UNITED STATES PATENT AND TRADEMARK OFFICE

APPLICATION NO.	FILING DATE	FIRST NAMED INVENTOR	ATTORNEY DOCKET NO.	CONFIRMATION NO.
10/707,291	12/03/2003	David W. Pratt	1053.30	1290
21901	7590	02/16/2006	EXAMINER	
SMITH & HOPEN PA 15950 BAY VISTA DRIVE SUITE 220 CLEARWATER, FL 33760			CHIN, PAUL T	
			ART UNIT	PAPER NUMBER
			3652

Office Action Summary

EXHIBIT A

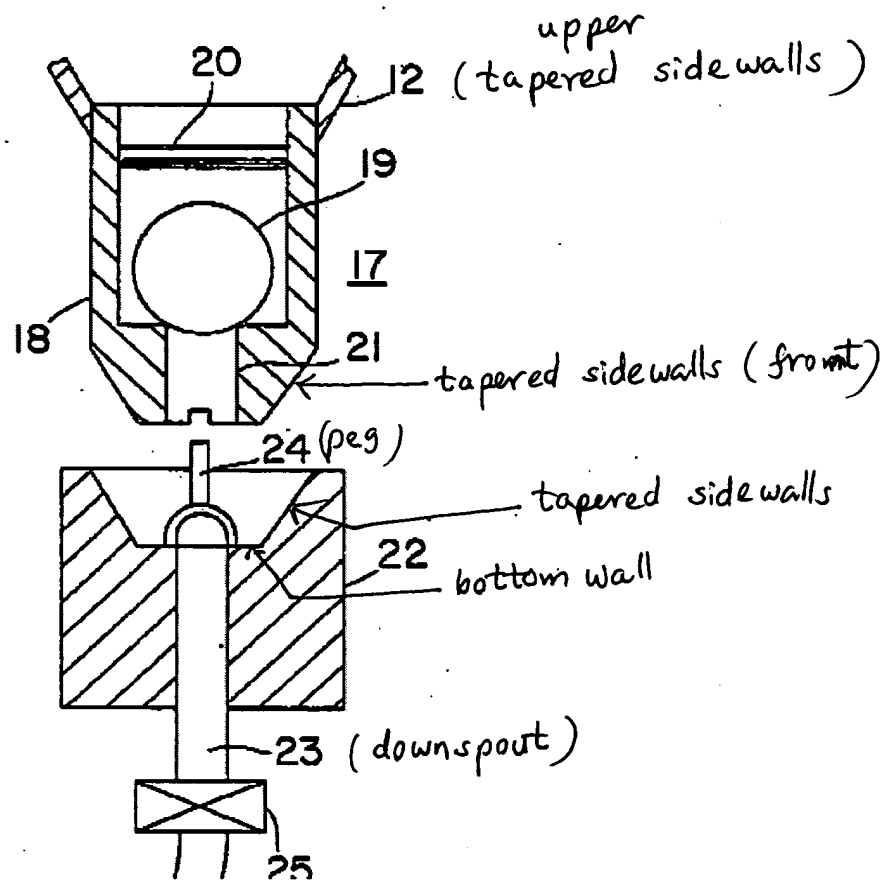
mounted in upstanding relation to said bottom wall, said peg being positioned adjacent said aperture. Note that Hunkin et al. (4,590,810) shows a valve housing having upper tapered walls (12) and lower tapered walls as shown in figure 1.

Exhibit A shows a bottom emptying device having a bottom wall and tapered side walls mounted about the periphery of the bottom wall wherein the bottom wall further having an aperture and a peg (24) mounted in upstanding relation to the bottom wall, and a downspout (23) depending from the bottom wall and being positioned substantially adjacent to the aperture. The downspout (23) has an inner bore or a lumen to allow the fluid flow from the downspout to the desired container.
